Letter of Objection to the development at Former Tower
Car Sales, Tower Close, East Grinstead, West Sussex
(now known as Whittaker House, 1 Leppard Walk) and
retrospective application DM/26/1449

Appendix A – original letter of objection for **DM/26/0432**

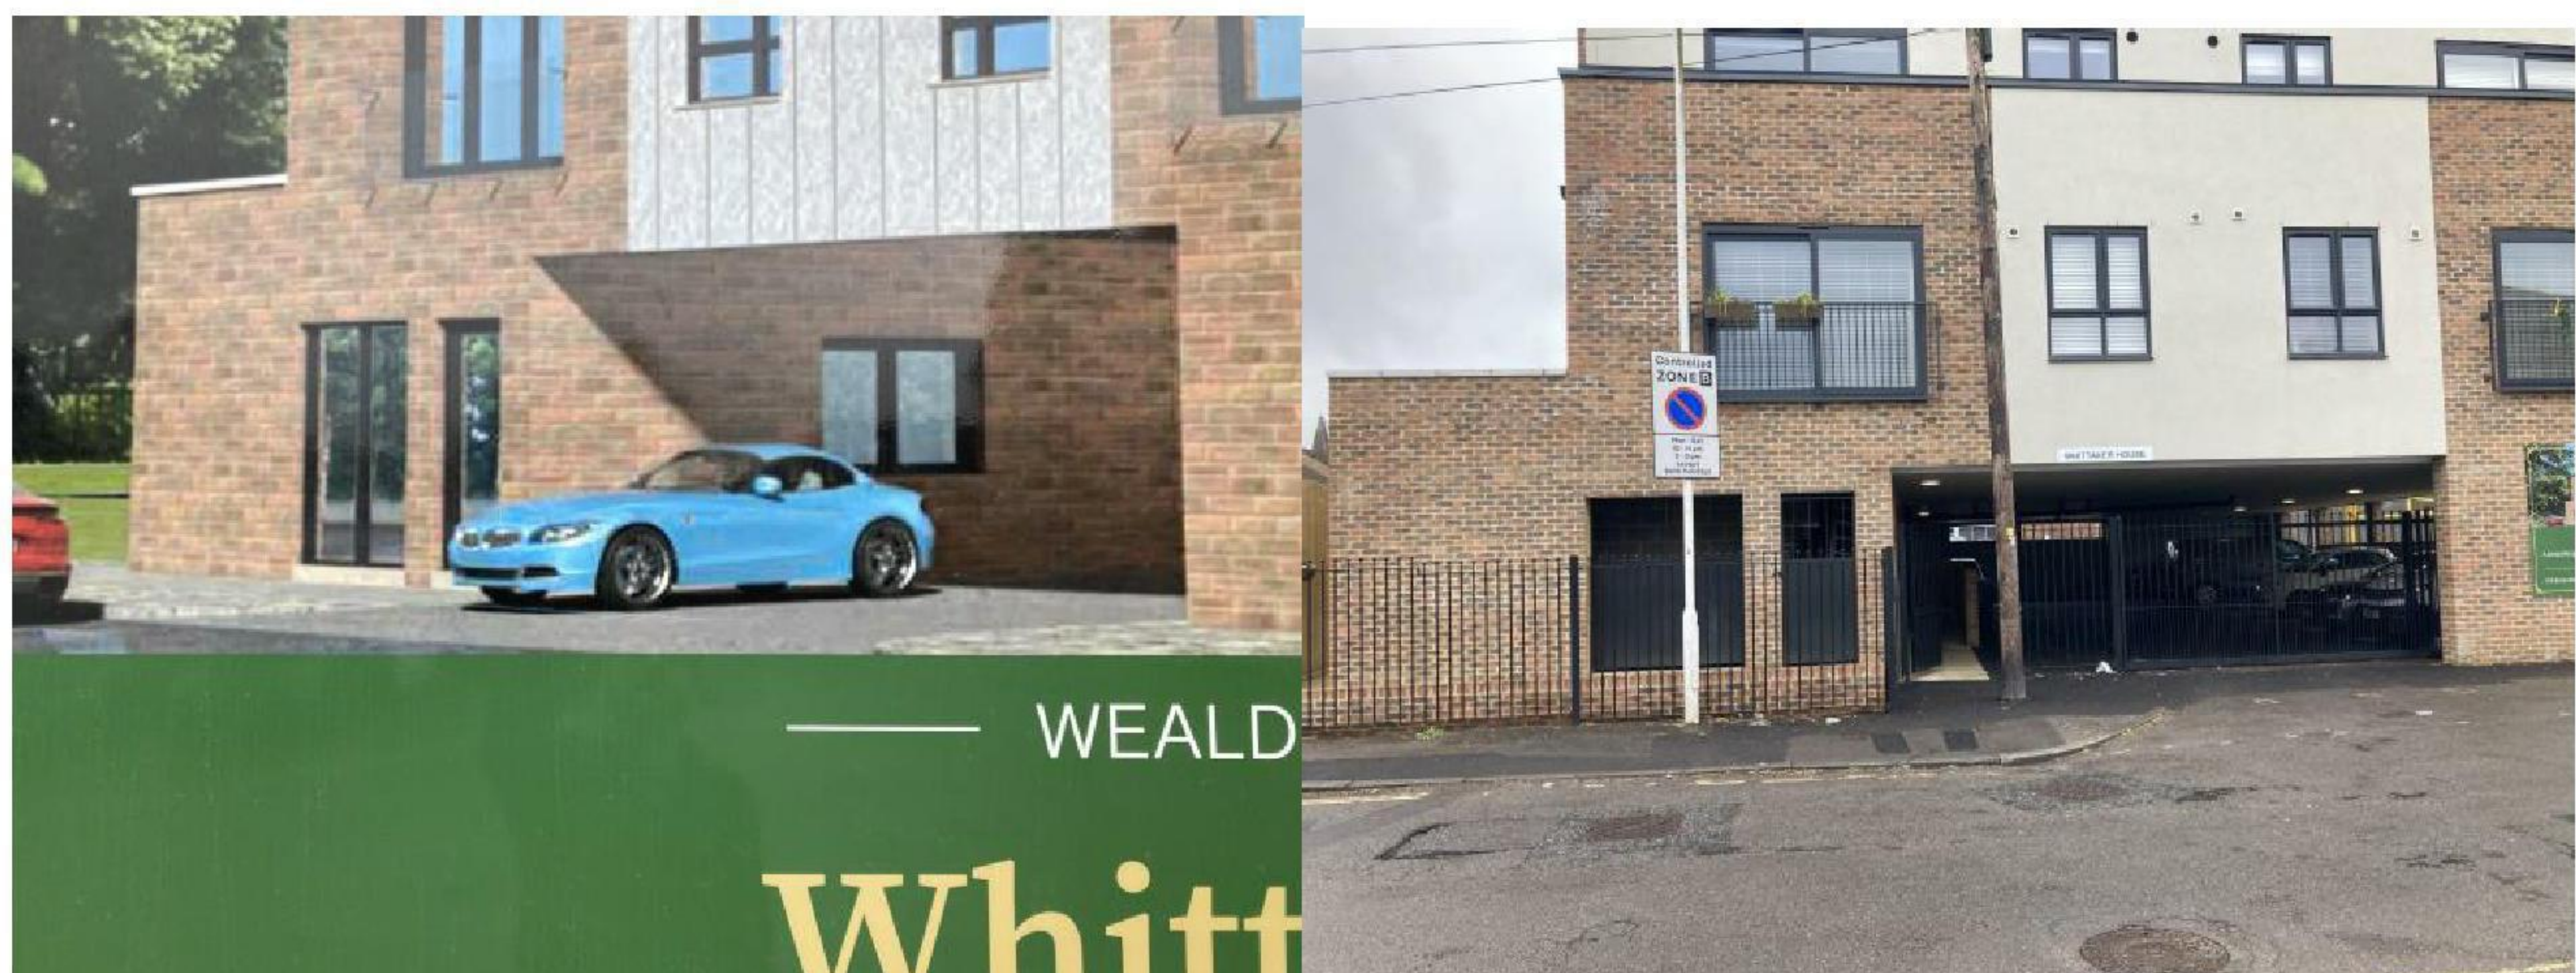
Starting with the outside of the property, Whittaker House was supposed to have a separate entrance, with a wide gated walkway to the right leading to a dedicated bike storage for 10 bikes, and 2 large refuse bins (sufficient bin storage for 8 properties). Both of these areas would lead into the entrance hallway, with the stairwell benefitting from opaque glass and entry into the undercroft.

The promotional material (same images as submitted plans); the current front of the building;

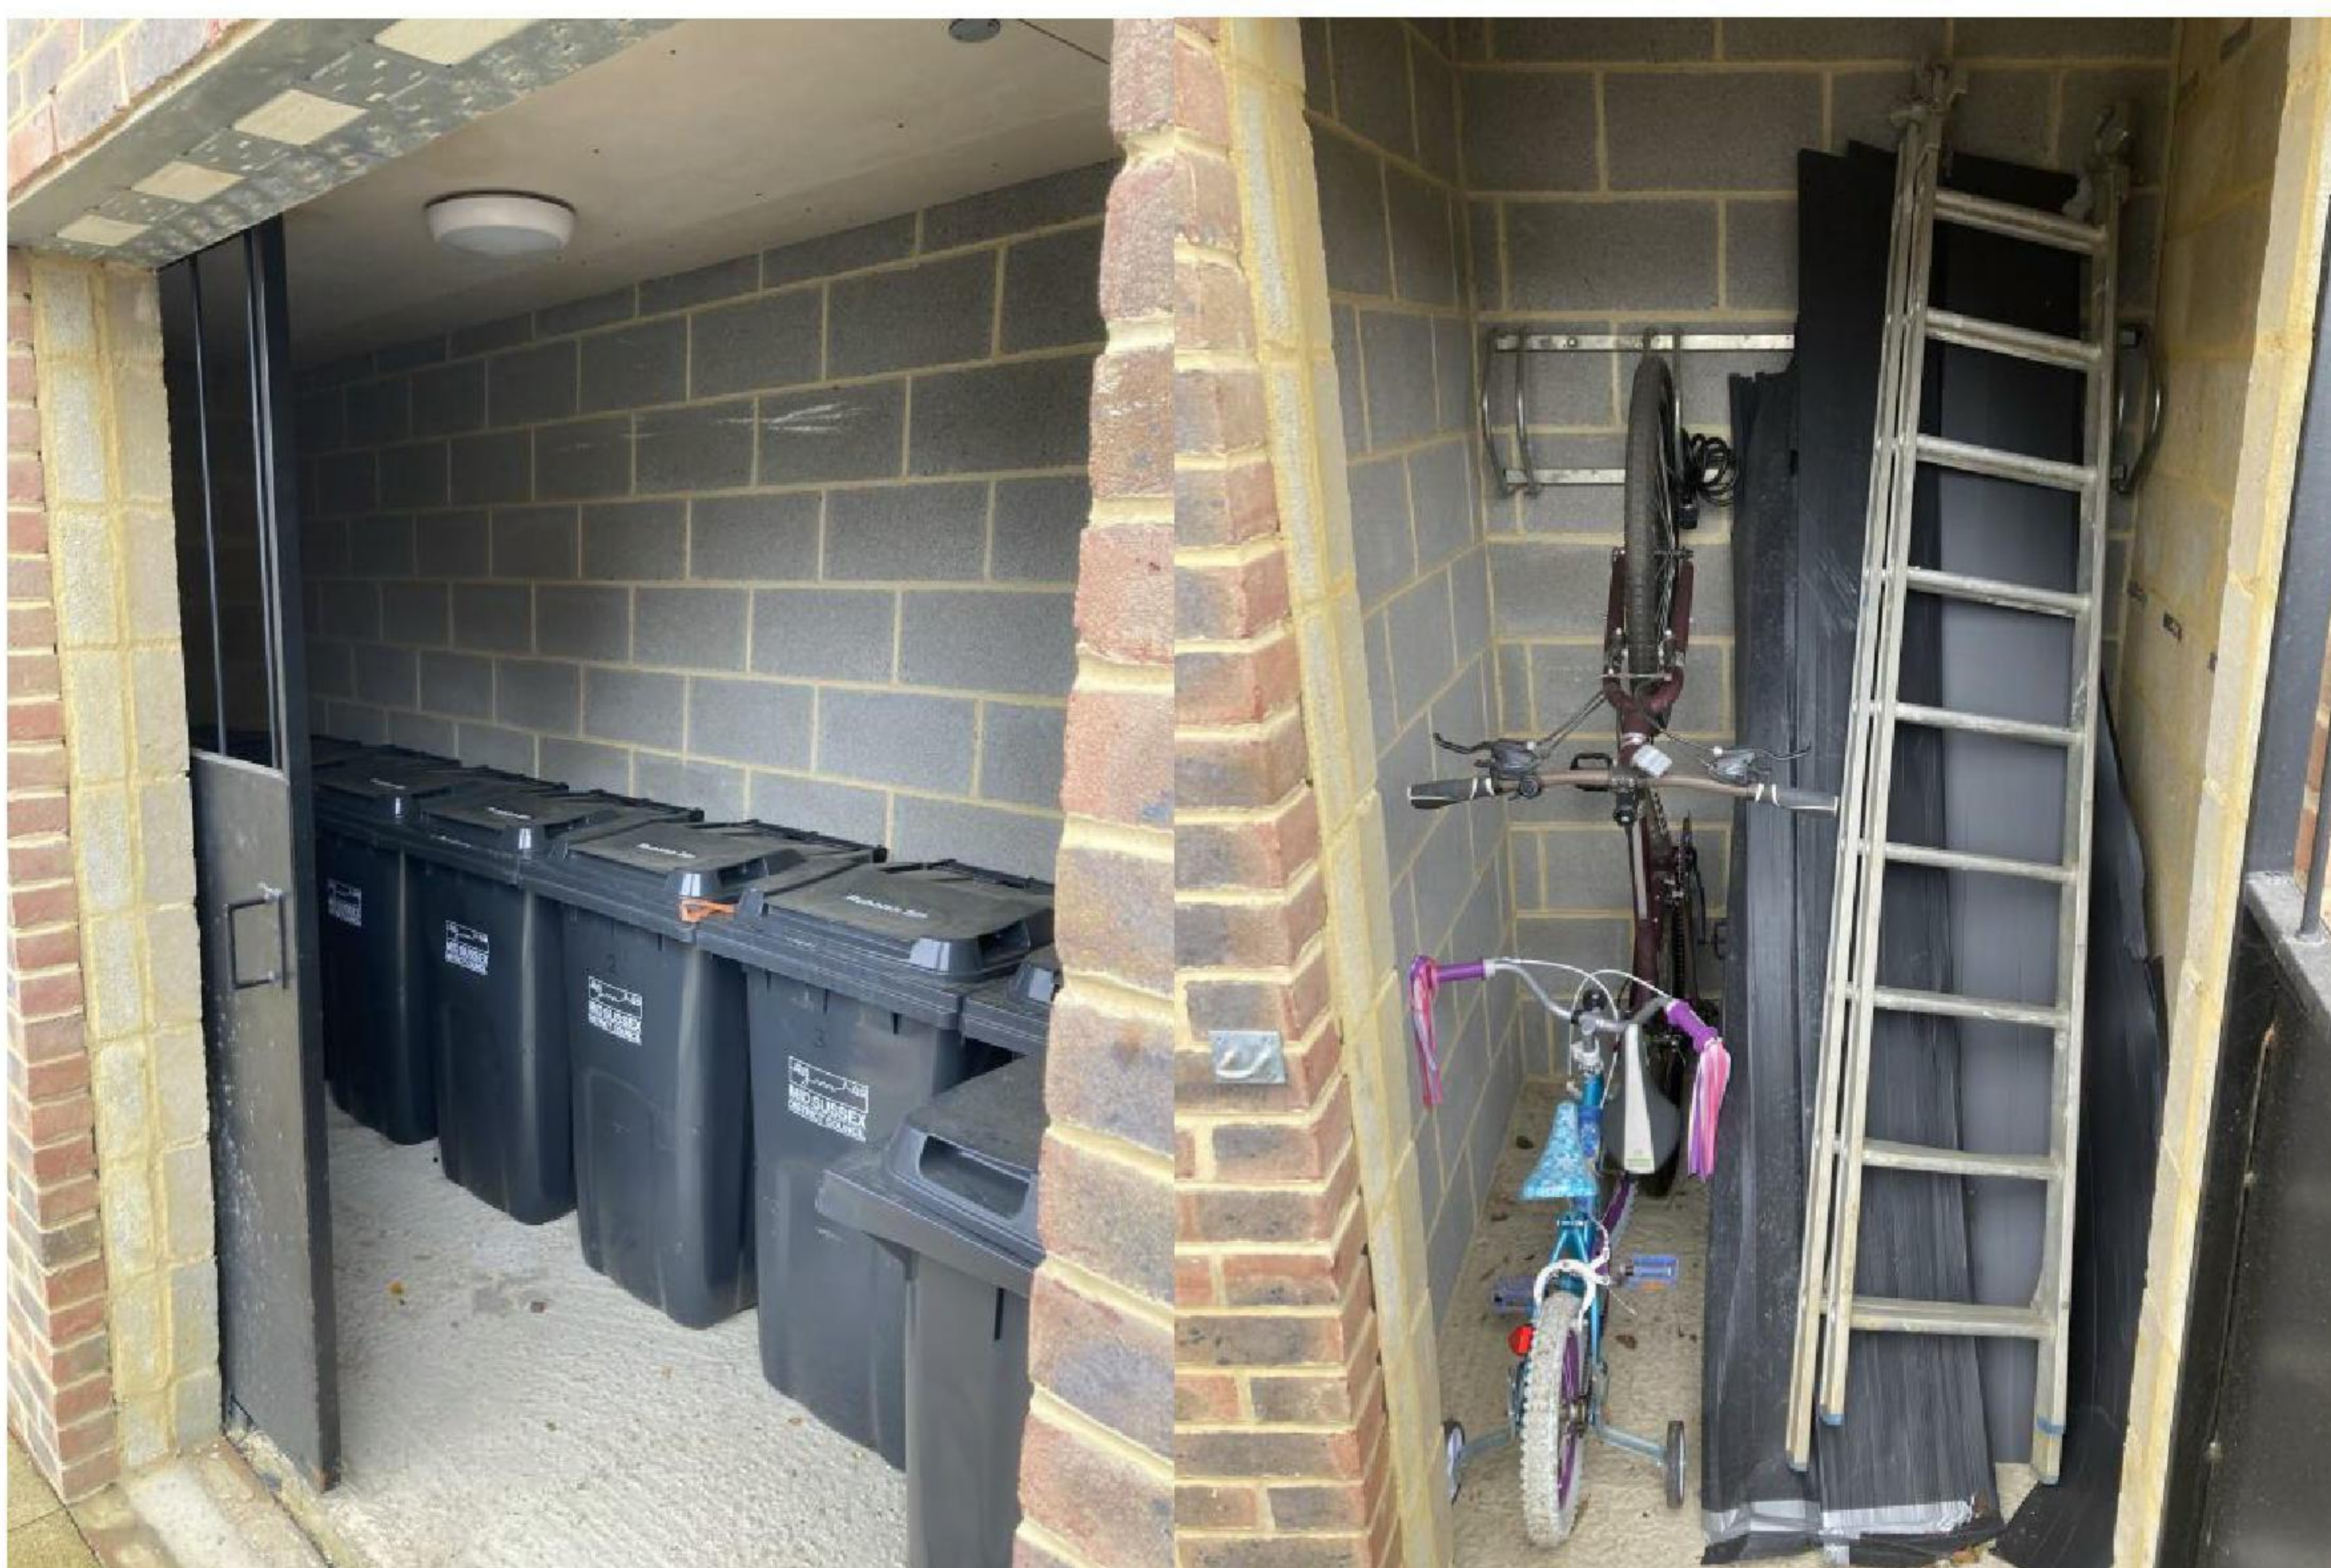
The entrance is now our 'dedicated bin and bike storage'. These are so unsuitable for the purpose as to be functionally useless. They remain unfinished, with unfinished brickwork (and bin storage) now forming part of the view for our neighbours. The bin storage area holds 8 bins, with the 9th squeezed in. Our recycling bins now live in the undercroft, as there is no 'dedicated bin storage'. The 'dedicated bike storage for 10 bikes' is honestly my favourite part of the development:

Dedicated bin storage; Dedicated secure storage for 10 bikes

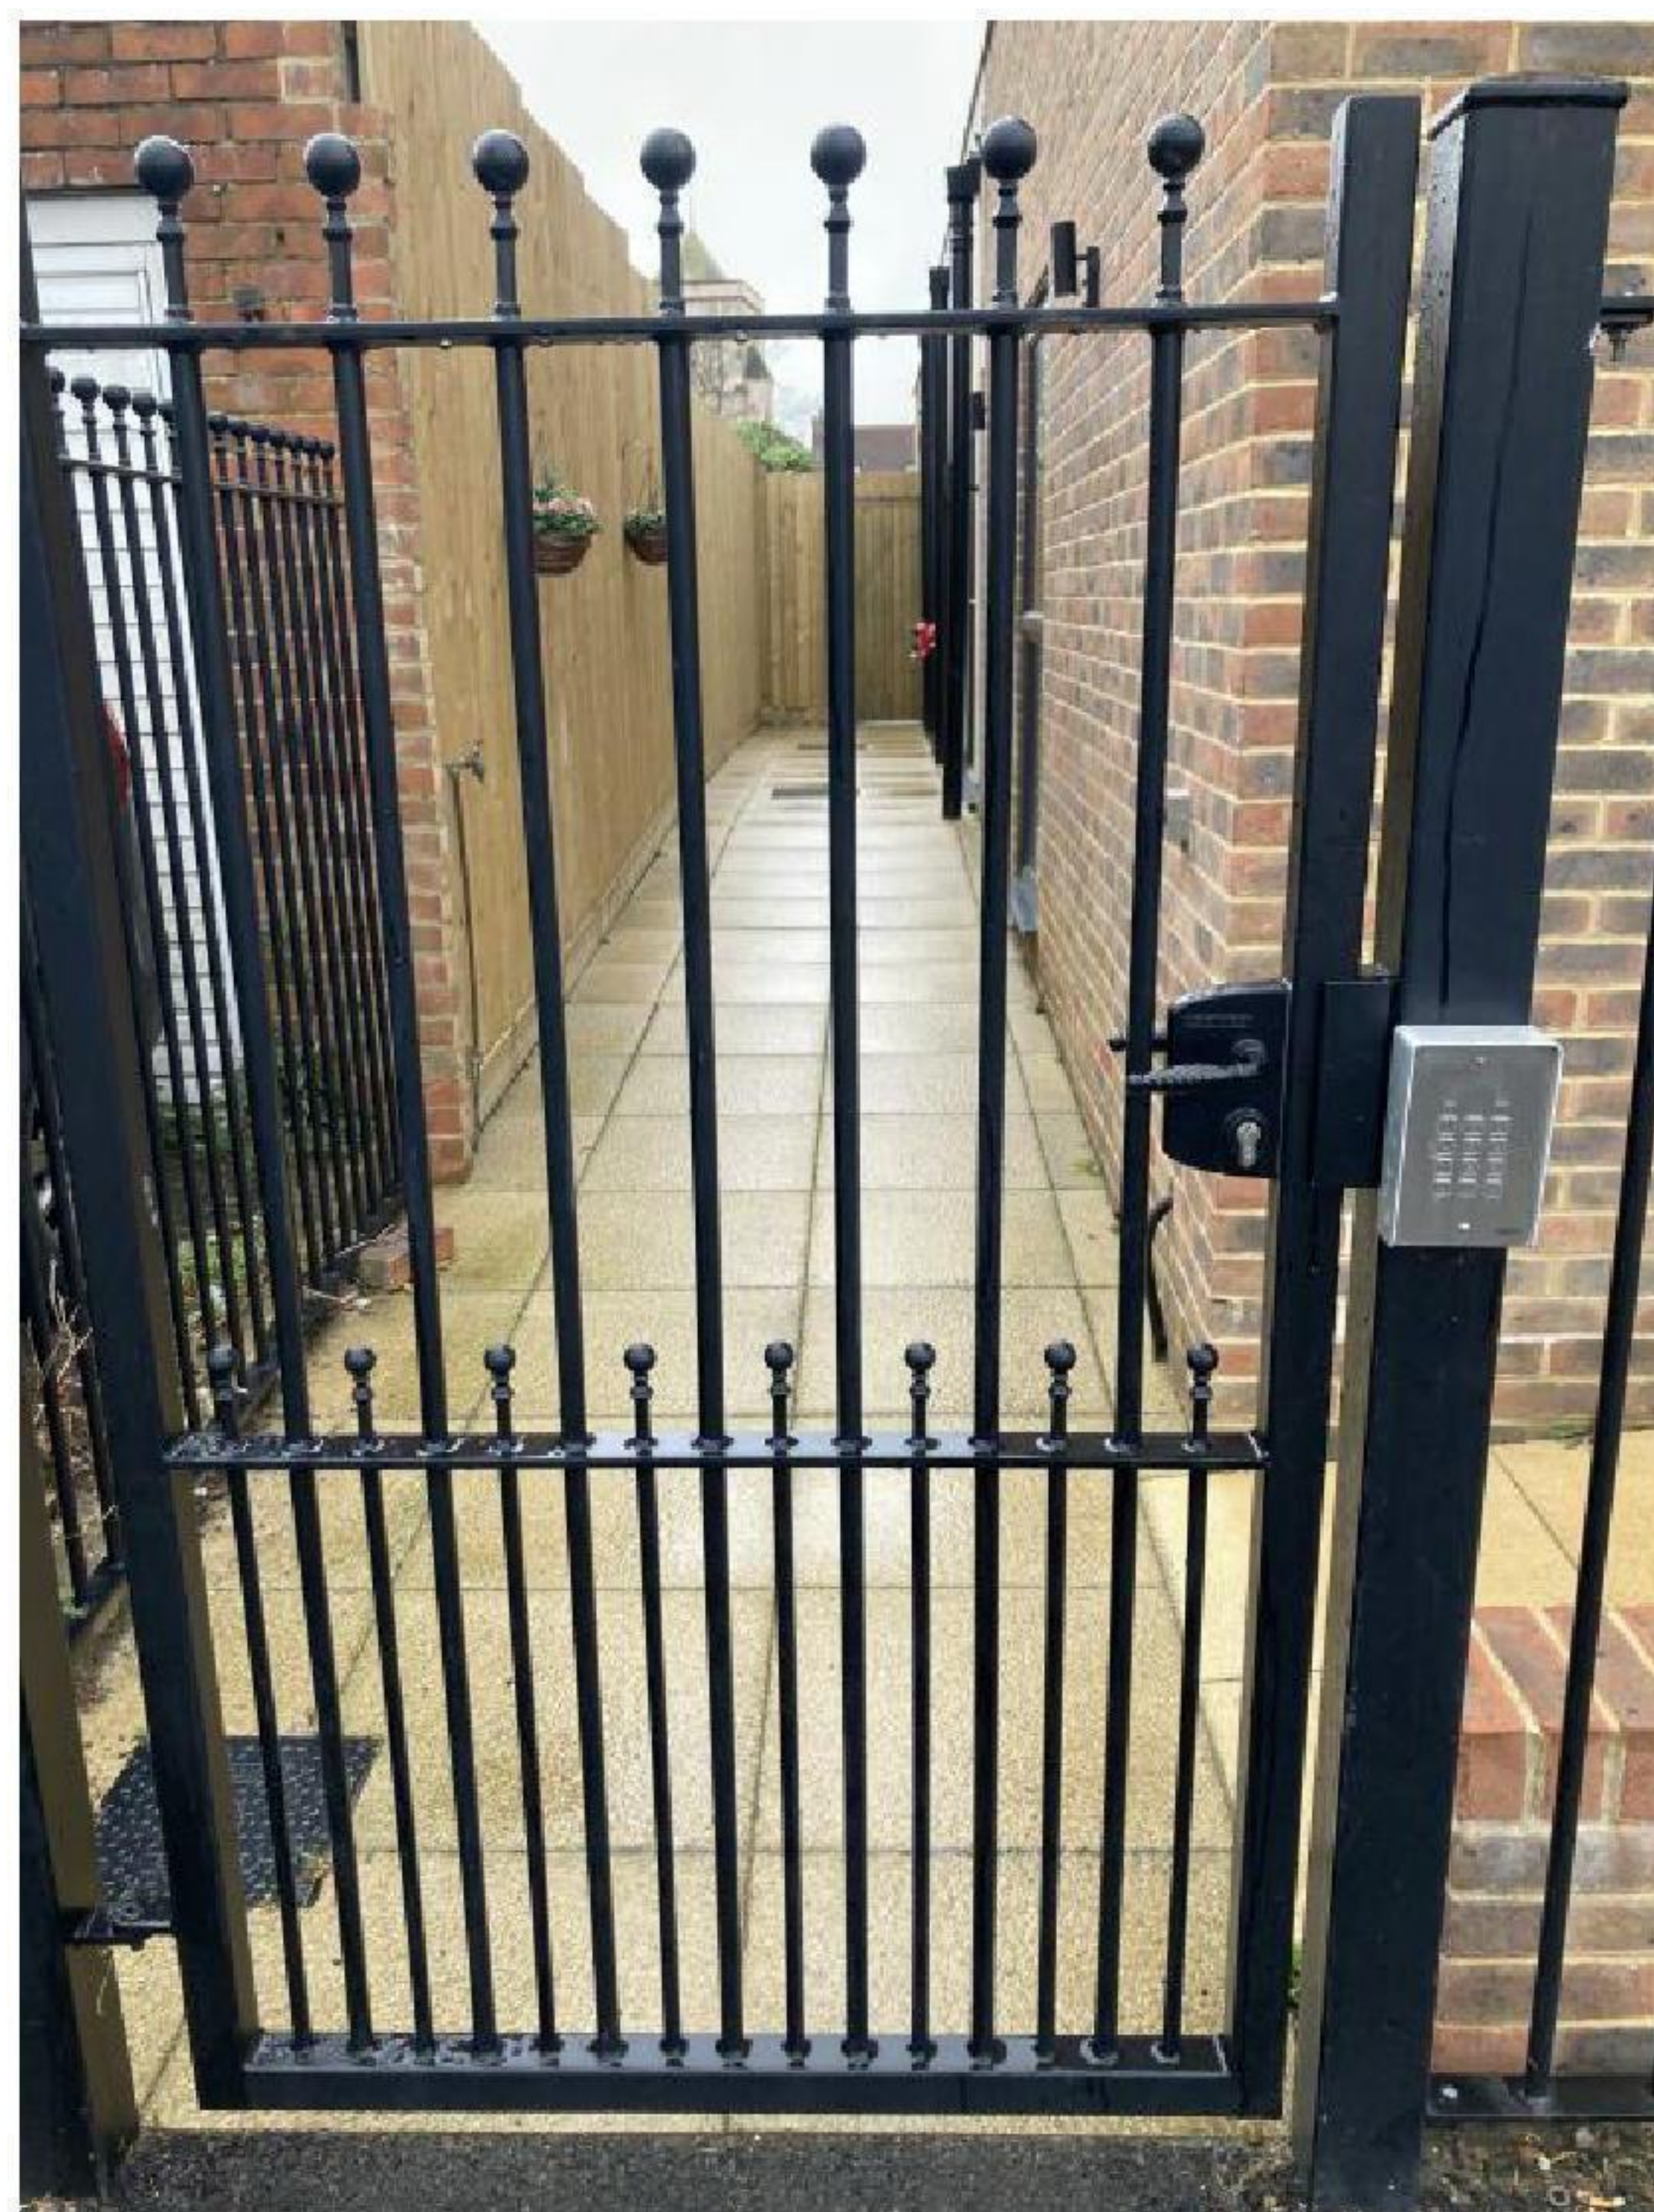
It would be funny if the property hadn't been marketed and sold as having dedicated secure bike storage, if said storage wasn't also mentioned when granting planning permission, and if several of the current freeholders hadn't purchased their property with this specific feature in mind.
